Environmental Impact Assessment Report (EIAR)

Largescale Housing Development at
Ringwood, Shean Upper, Blarney, Cork City

Addendum Statement

Client	Clockstrike Ltd.
Project Title	Ringwood LRD
Job No.	CON23002
Document Title	Environmental Impact Assessment Report (EIAR) Addendum Statement
Number of Pages	17

Figure 4: Proposed Site Compound Location

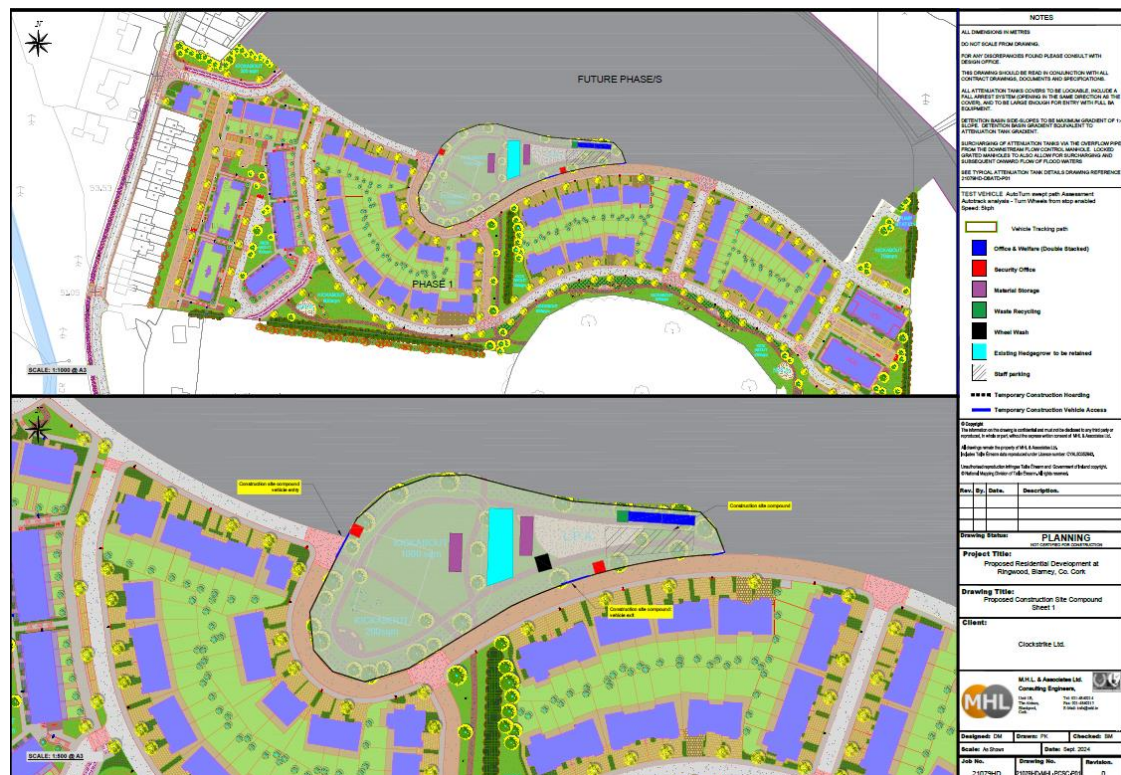
The location of the proposed construction compound has been clarified in the RFI response. Its location had already been identified on Figure 5.1 of the submitted Construction Traffic Management Plan. This location was taken into consideration in the assessment undertaken in the submitted EIAR. No material change in the assessment undertaken or conclusions arrived at therefore arise.

The compound is now also shown on Drawing Nos. 21079HD-MHL-PCSCP01 and 21079HD-MHL-PCSCP02 enclosed with this Response submission.
